PCN – Product Change Notification

Document No PCN-A-1040528 **Revision** 1.1

PCN Topic: Mechanical change of Winmate 19” open frame panel pc and display

Comparison Table

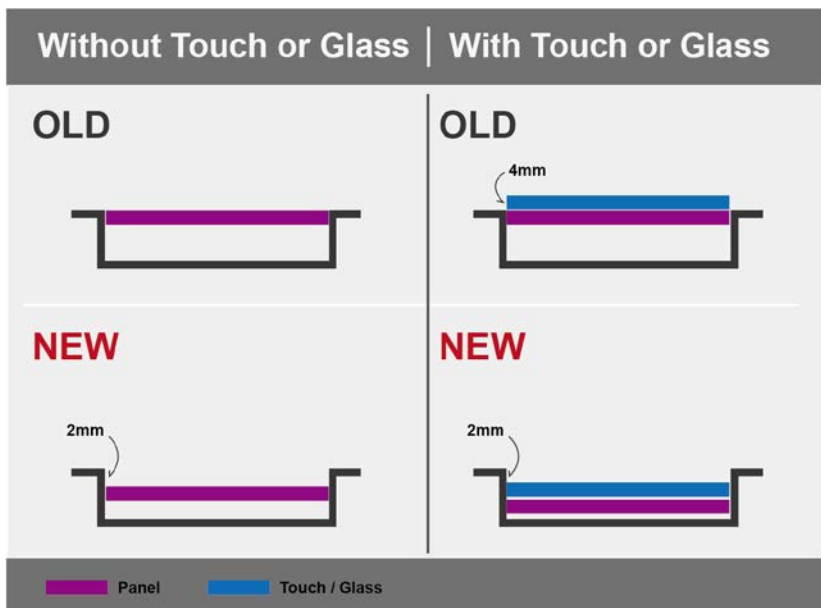
The mechanical design of the panel in the 19” open frame Display and PPC is changed, for the panel without any touch or glass, the position of the panel will be 2 mm lower. In the other hand, for the panel with touch or glass, the position of the panel and glass will be 2 mm lower with the surface of the frame.
